**CONTRACT DOCUMENTS & TECHNICAL SPECIFICATIONS
ADDENDUM NO. 5**

**DELAWARE BAYSHORE BYWAY
LITTLE CREEK BOARDWALK AND WILDLIFE VIEWING TOWER
CONTRACT NO. FW-2-15**

Contract No.: FW-2-15

Date of Issue: February 27, 2018

17 Typical Boardwalk Framing Section

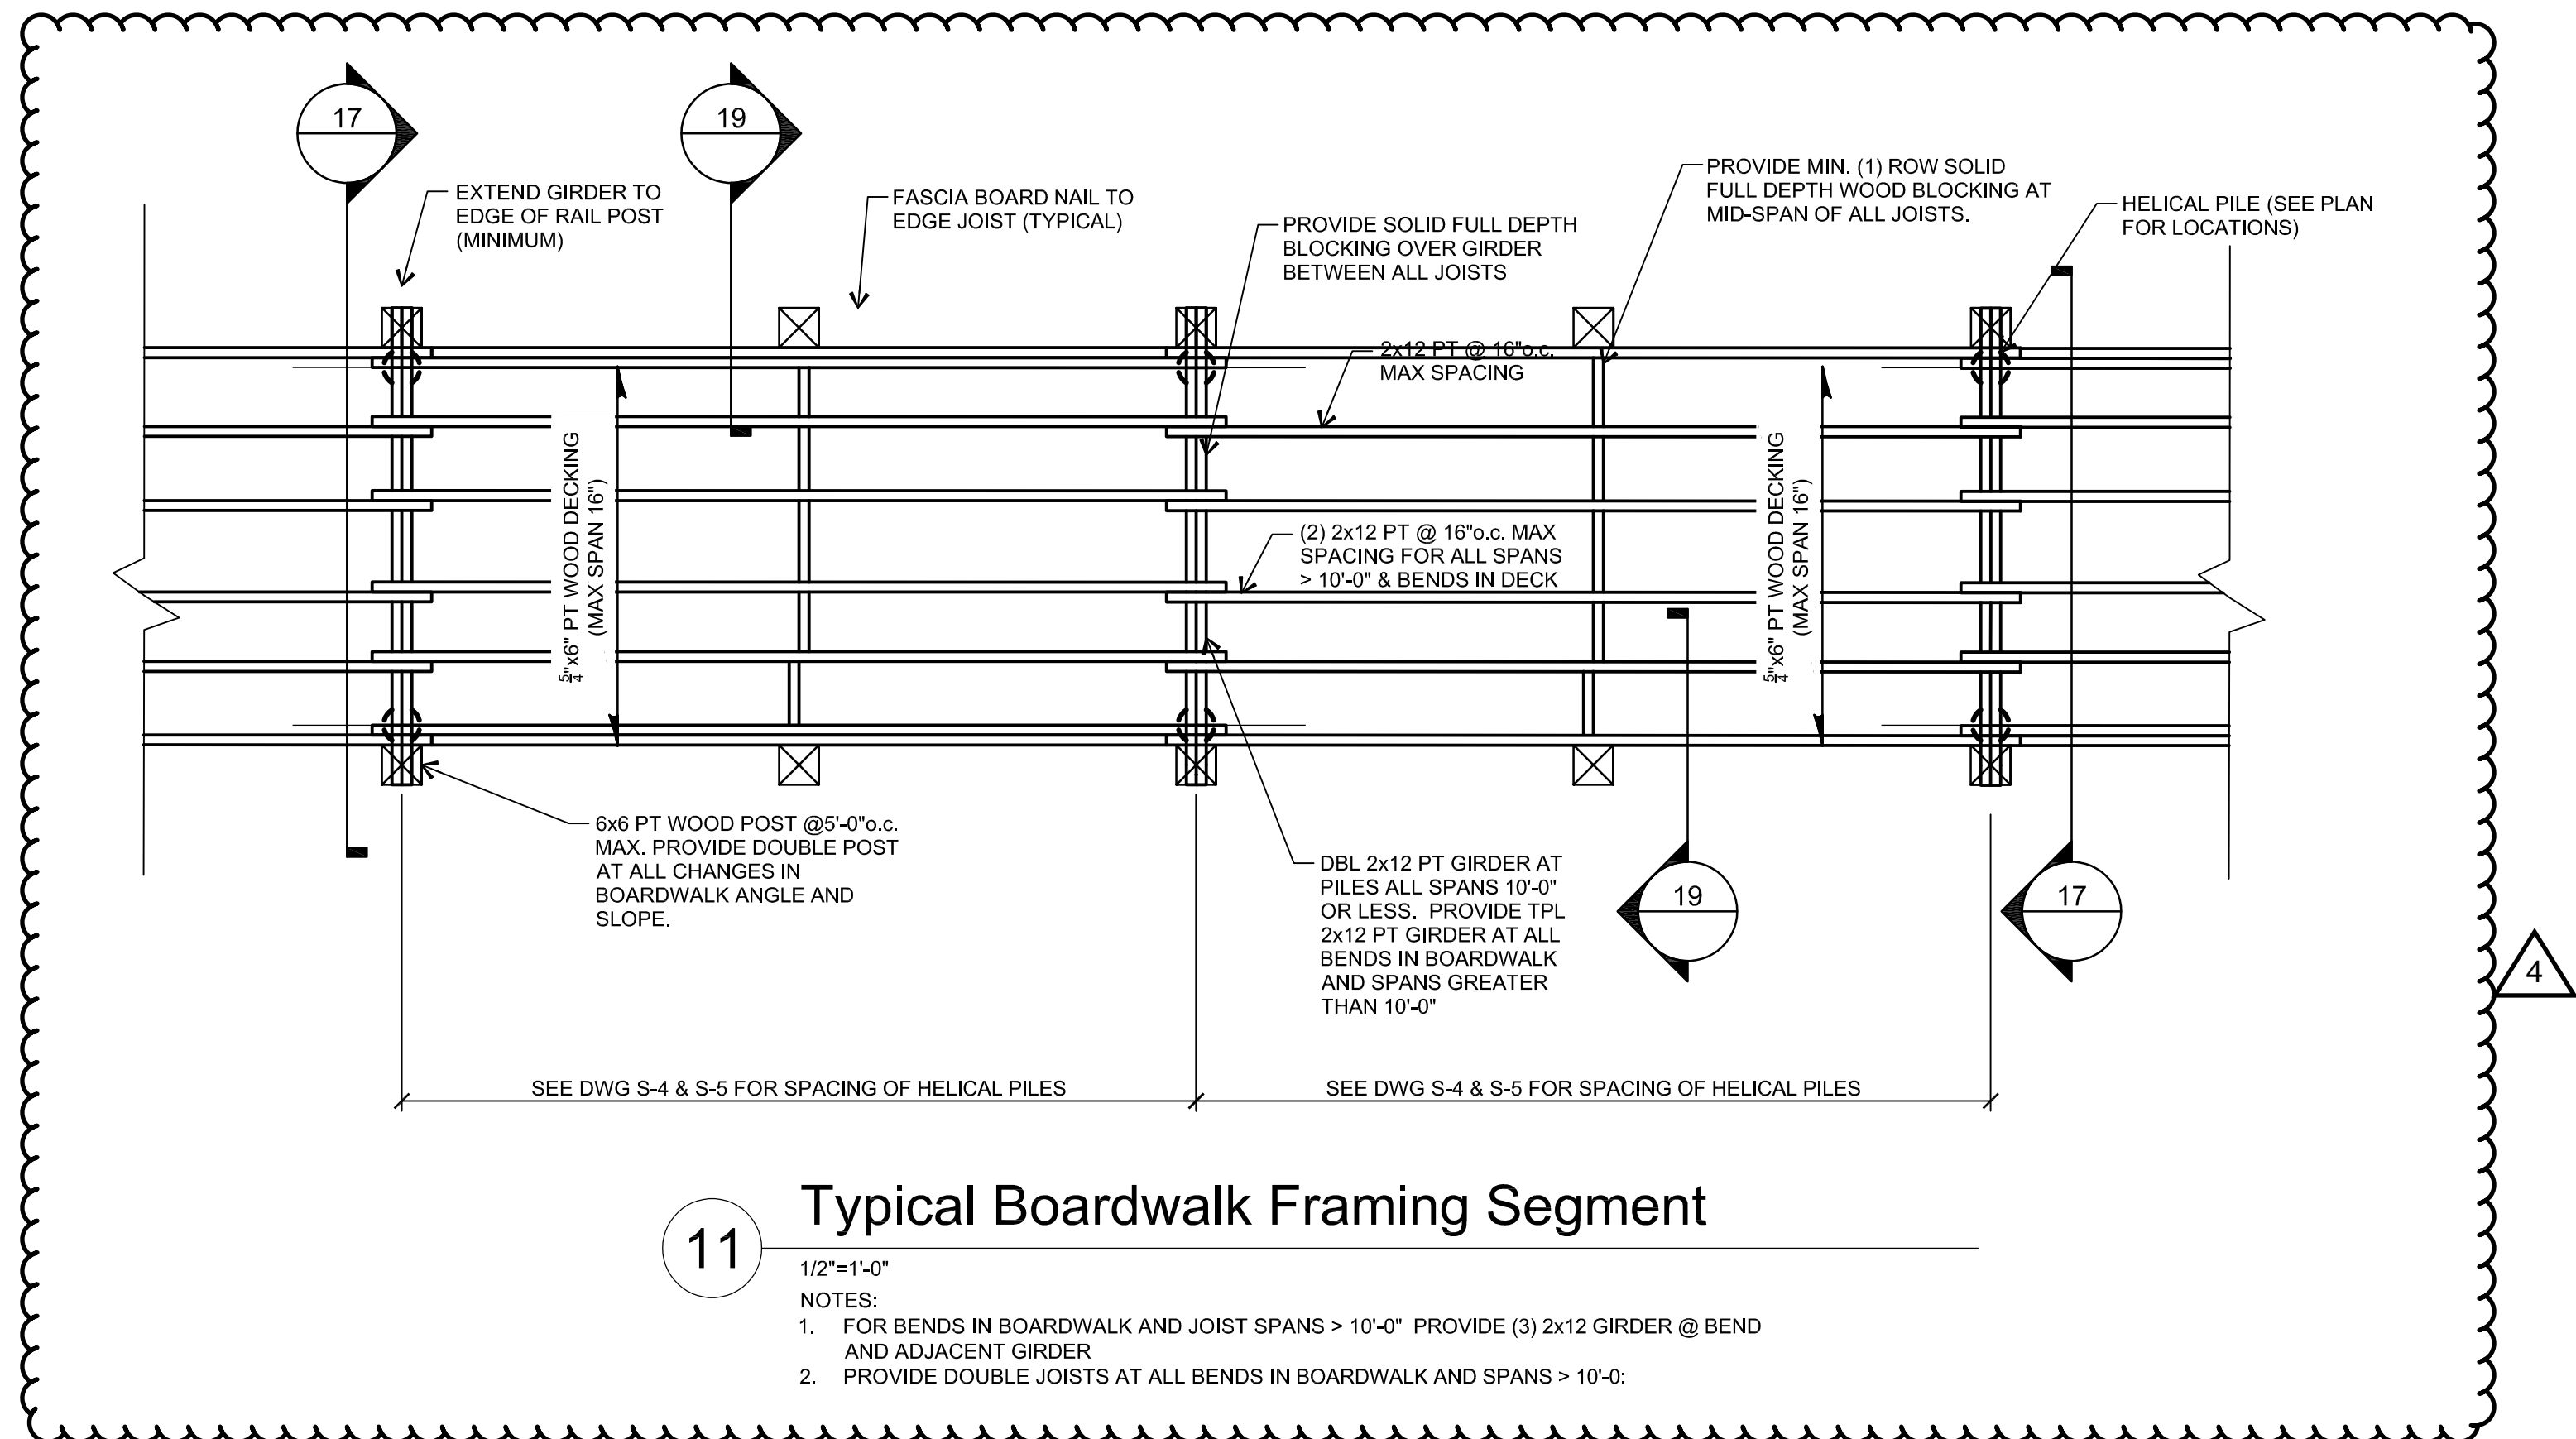
Q2. Detail 17 Typical Boardwalk Framing Section of Plan Sheet S-7 shows the edge of the decking, the outside face of the rail posts and the ends of the girders all lining up, however, detail 11 Typical Boardwalk Framing Segment on the same sheet notes to extend girder 3" beyond edge of boardwalk (minimum). Please clarify if all members are to be flush or not.

A2. All members are to be cut flush.
